**PROPOSED FINAL MITIGATED NEGATIVE DECLARATION (07-MND-003)
ADDENDUM DATED AUGUST 1, 2008**

**CITY OF GOLETA
FINAL MITIGATED NEGATIVE DECLARATION**

- 1. PROJECT TITLE:** Marriott Residence Inn and Hollister Center; Case Nos. 07-007-GPA, -OA, -DP, -TPM; 07-167-DP AM
- 2. LEAD AGENCY NAME & ADDRESS:** City of Goleta, 130 Cremona Drive, Suite B, Goleta, CA 93117
- 3. CONTACT PERSON & PHONE NUMBER:** Laura M. Bridley, 805/966-7260 /Patricia Miller, 805/961-7540
- 4. APPLICANT:**

Figure 9: Parcel 2 Parking Lot Configuration

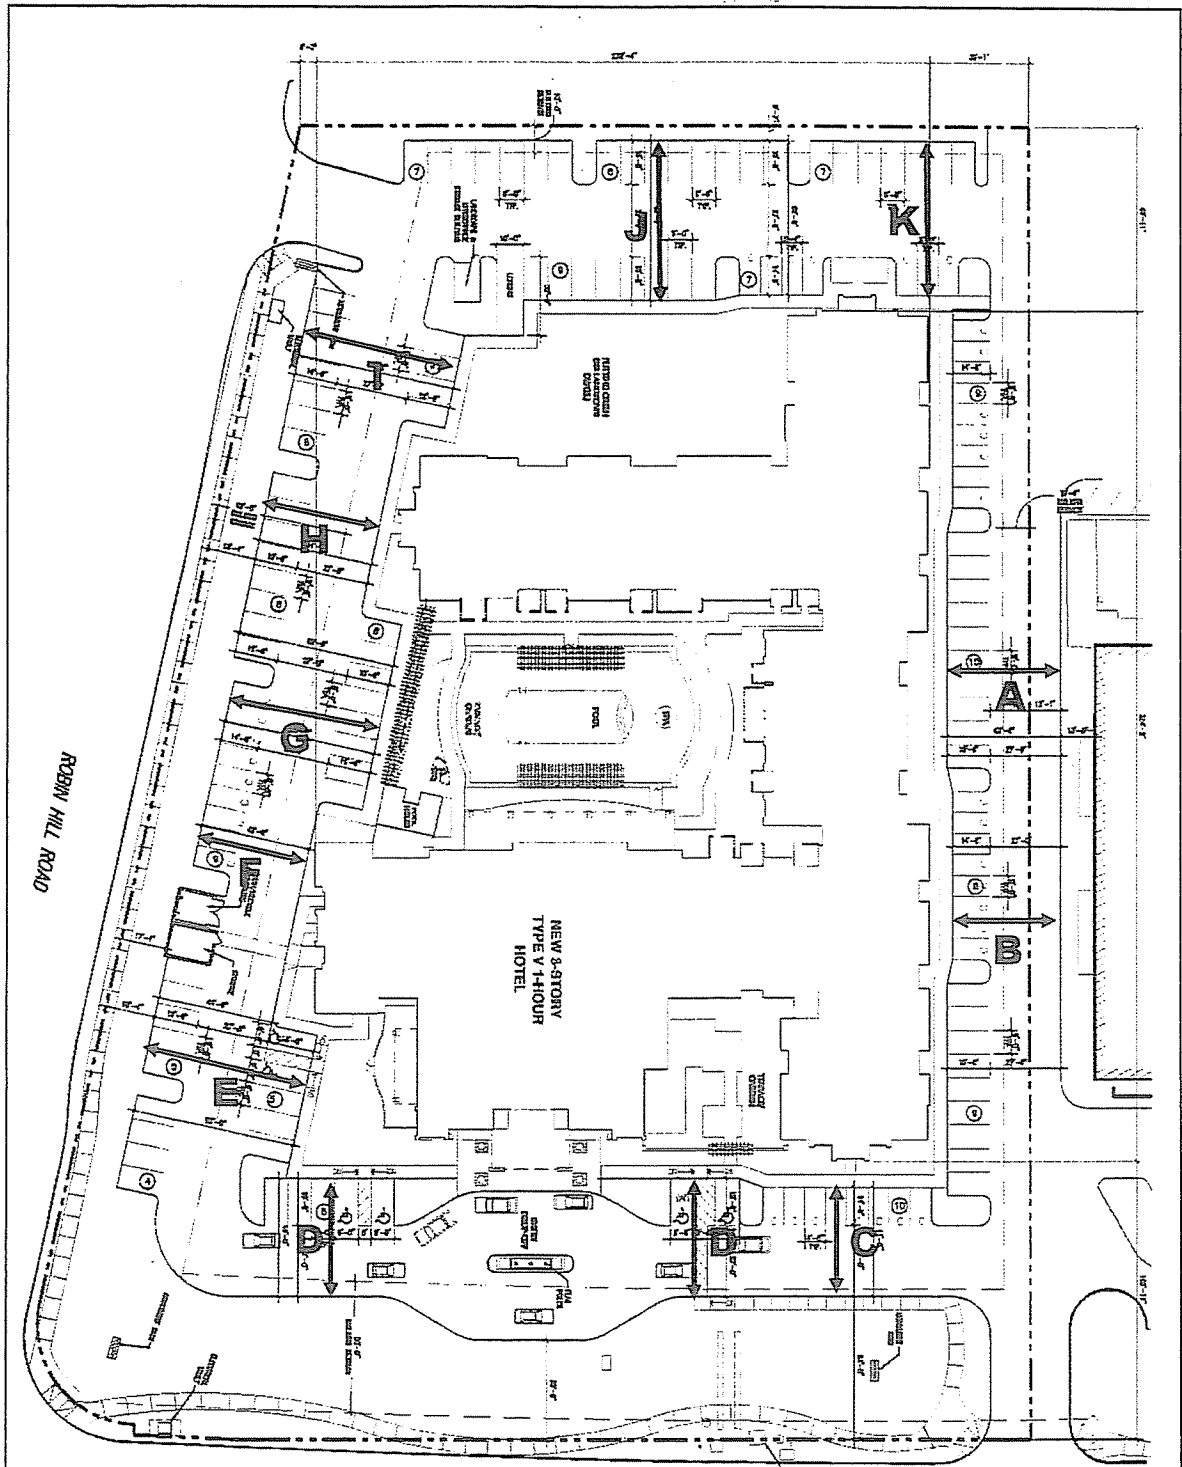
In regard to Parcel 2, a detailed review of the site plan submittal for purposes of this Mitigated Negative Declaration showed several possible inconsistencies with adopted off-street parking development standards. These discrepancies included parking stall dimensions, drive aisle widths, lack of loading space and compact parking in excess of the maximum allowed. The applicant was advised of these deficiencies and submitted a revised plan dated November 6, 2007. While the revised layout is compliant with design standards (Figure 9), the modifications result in further encroachments into perimeter parkways. Exceptions to development standards are permitted for Development Plans through Goleta Zoning Ordinance Section 35-317.8. Provided that decision makers find the exceptions to be justified, the modification would be less than significant.
